PR/1039/23

Record of Executive Business and Chief Executive's Order

Reg. Reference: SD22A/0466 **Application Date:** 21-Dec-2022
Submission Type: Additional **Registration Date:** 08-Aug-2023
Information

Location: 124, Templeville Drive, Templeogue, Dublin 6W

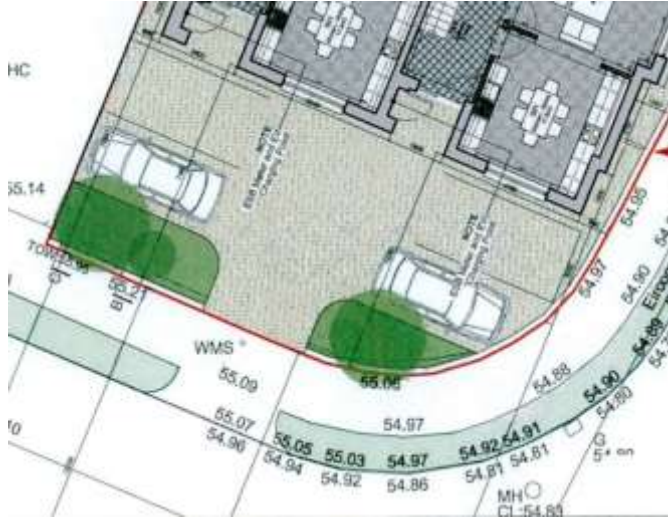
The proposed southern entrance is located close to the road junction and intended to serve 2 dwellings and 4 new carpark spaces. Roads Department have concerns regarding the significant increase in vehicular activity this new entrance will generate, and the associated increase in risk that will arise to all footpath and road users.

2 new entrances are proposed on the eastern side of the site. This section of Templeville Drive currently allows for additional parking for local residents and visitor car parking and is very much utilised. The introduction of two new entrances on this section of road will reduce the existing parking arrangements as parking restriction proposals may be required in order to allow for safe access/egress to and from these entrances.

Additional information would be required in the form of AutoTRAK analysis to inform whether a revised road layout would work safely, and to the satisfaction of the Roads Department. All egress movements will it seems be reversing movements and this is a serious concern to the Roads Department.
